Clarifications to the VSP 2011 Operations Manual

The following item numbers are being clarified in response to industry questions. Text from the *VSP 2011 Operations Manual* is printed first, then the clarification.

Figure 1. Shortest Distance in a Rectangular Pool

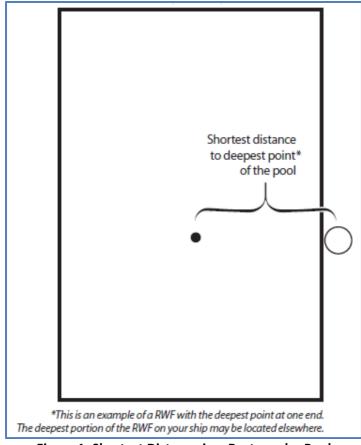
The rescue or shepherd's hook must be long enough to touch the bottom center of the deepest portion of the RWF plus 2 feet (0.6 meters) as measured from the closest edge without an obstruction. This edge can only be used for measurement if someone could freely walk down both sides without an obstruction such as a waterfall, fountain, statue, etc.

For a rectangular pool, the shorter distance would be from the long side of the rectangle as long as there are no obstructions (Figure 1). The 2 feet (0.6 meters) is measured from where the shepherd's hook crosses the fill line of the RWF.

Figure 2. Measurement in RWFs with a Beach Level

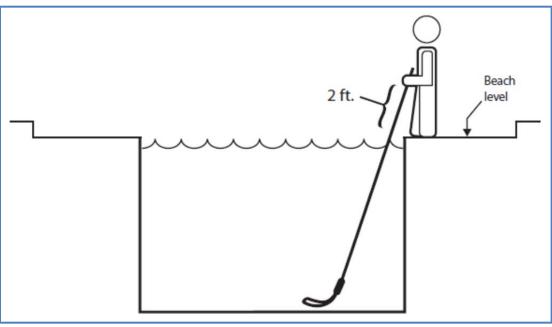
For RWFs with a beach level, the measurement can be from the edge of the tub (Figure 2).
